18 May 1960

- B. 1. At/several points in the text of this report, reference is made to the bandwidth of the ASR-1 placing a limitation on the allowable deviation of the RT-3R. It is felt that if the BT-3R deviation is set as suggested in the RT-3R operation manual, the input from an operational migrophome installation would have insufficient amplitude to cause the transmitter deviation to exceed the bandwidth of the ASR-1.

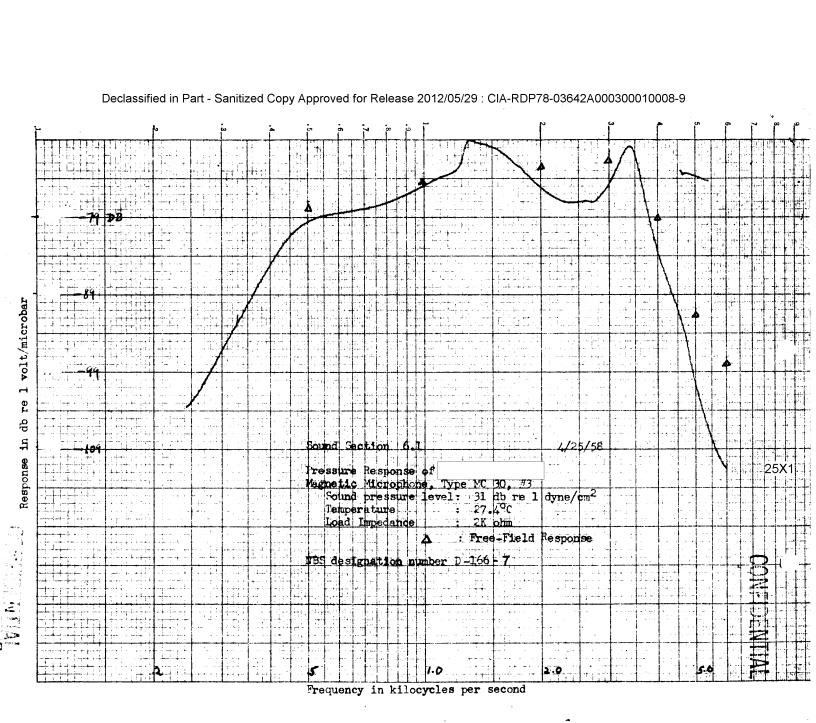
graph ordinate represents response and is a function of (voltage)

EXAMPLE: BK-6B CURVE WITHOUT

RESPONSE = - 86 db MAX

SUPPOSE S. P. AT MIC

15+71 db re .0002 da.

AMPLITUDE OF MIC OUTPUT IS CALCULATED

VOICE PRES. = - 3 db re 1 dyne (74-71)

E = -86+(-3) = -89 db re 1 VOLT

$= \frac{-\binom{89}{20}}{(1 \text{ V.})} = 10 = 35.4 \text{ MV.}$
